Proposal Request

Project:	Twin Falls Fire Station 2	PR No.:	PR-02
Project No.:	20-041	Date Issued:	May 27, 2022
Owner:	City of Twin Falls 214 Cheney Drive Twin Falls, ID 83301	Issued To:	Starr Corporation 2995 E 3600 N Twin Falls, ID 83301
Contract Date:	April 12, 2022	Attn:	Jason Derricott

ITEM 1: PR-02 Dedication Plaque Design and Room Signage Schedule

5 TRUSS GIRDER TO CMU WALL
S5.01 1" = 1'-0"

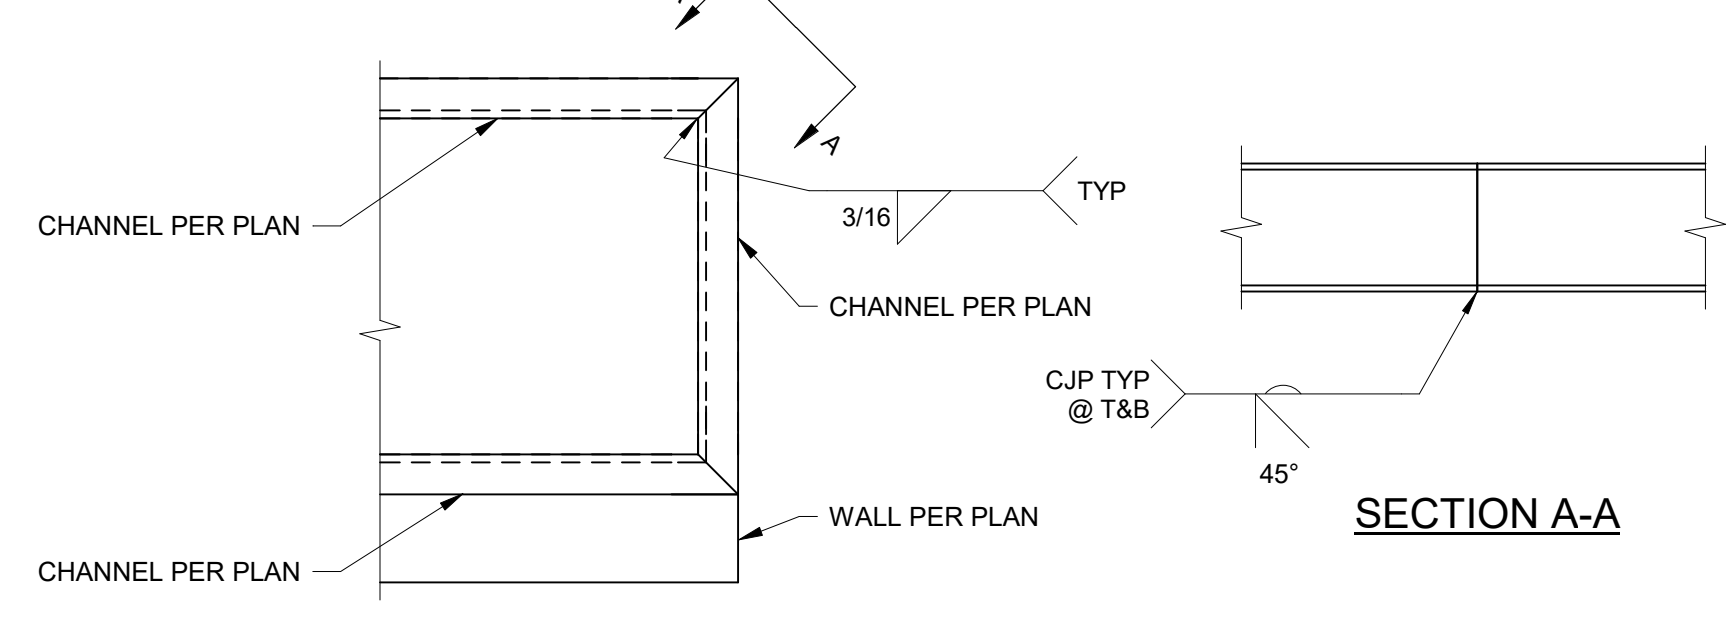
- Detail 5: Updated the detail to show HSS to account for the roof slope at ridge and sloped ply conditions.
- Detail 10: Updated the detail to show notched HSS to account for the roof slope at corner pier condition.
